LINCOLN COUNTY
DEPARTMENT OF ENVIRONMENTAL HEALTH
AFFIDAVIT OF WASTEWATER TREATMENT AND DISPOSAL SYSTEM COMPLIANCE REVIEW FOR SYSTEM INSTALLED, REPAIRED OR REPLACED WITHOUT A VALID PERMIT

Describe: 5 90' trenches, gravity fed manifold distributed system.

Address or Location: 37 Lupine Dr. Rexford, MT 59930

LOT LAYOUT

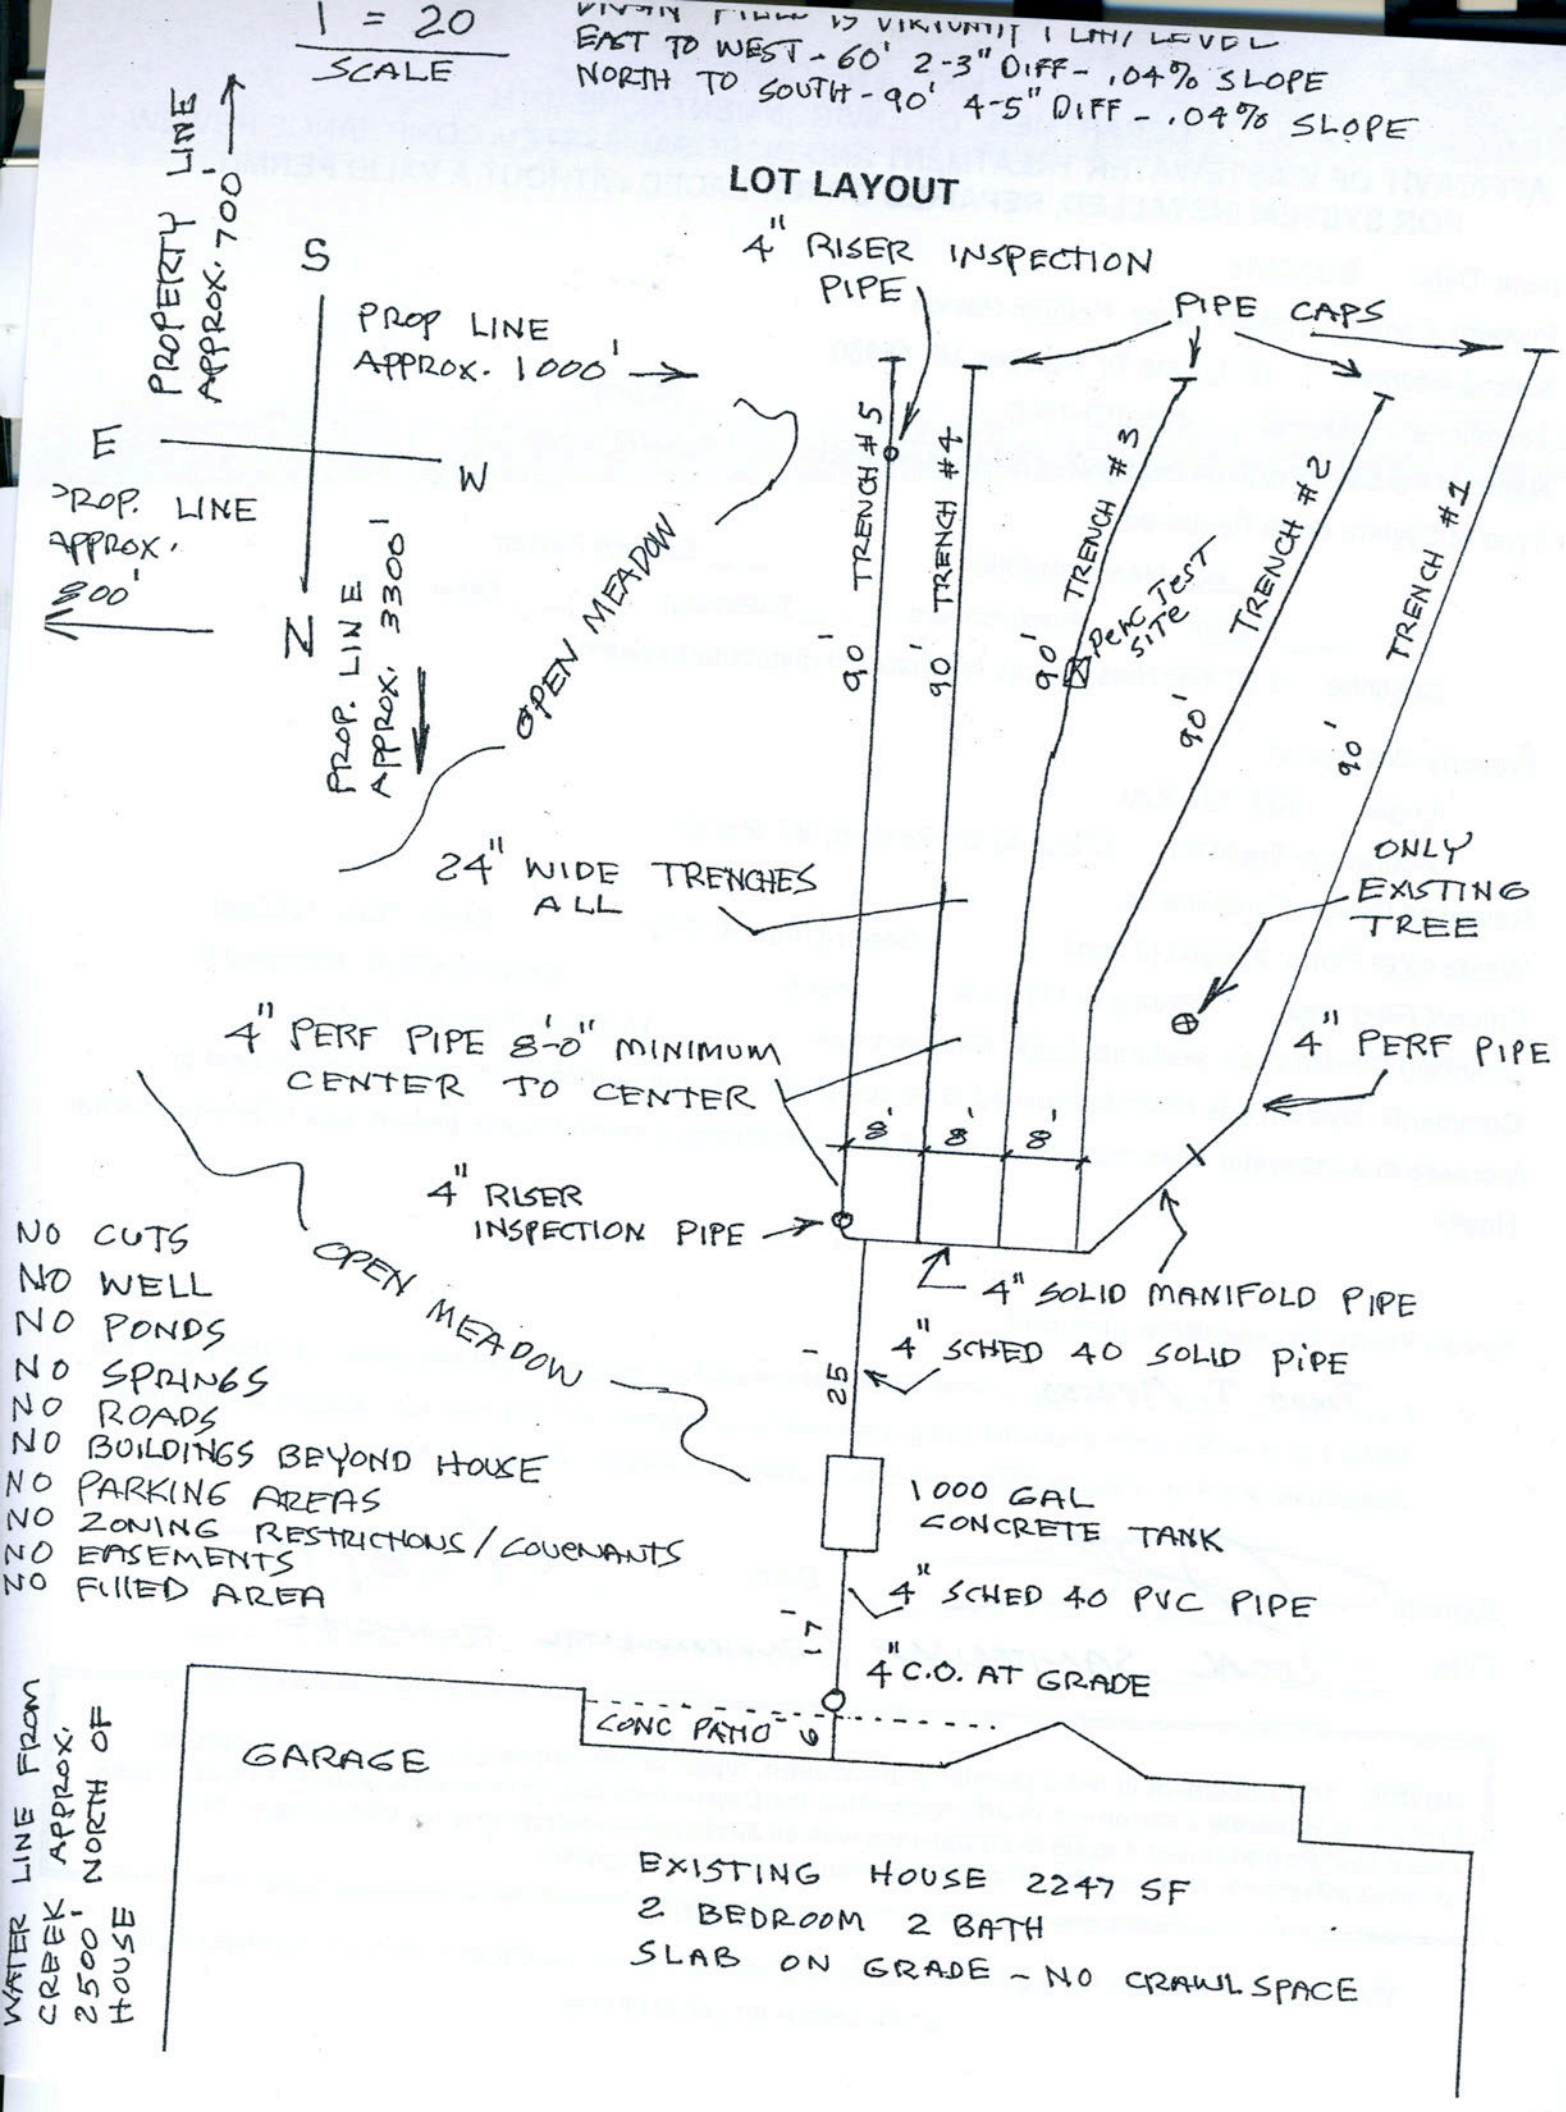
Comments: System has been determined to be compliant. Any future extension, repair, replacement or increase in wastewater flows must be reviewed and permitted by Lincoln County Department of Environmental Health.

I, JACOB T. MERTES *, have inspected/reviewed the components of this system as listed above and found it to be in compliance with the sizing, construction, orientation and operating requirements of Chapter 17, Subchapter 9 A.R.M., Circular DEQ-4 and Lincoln County Wastewater Regulation #3.*
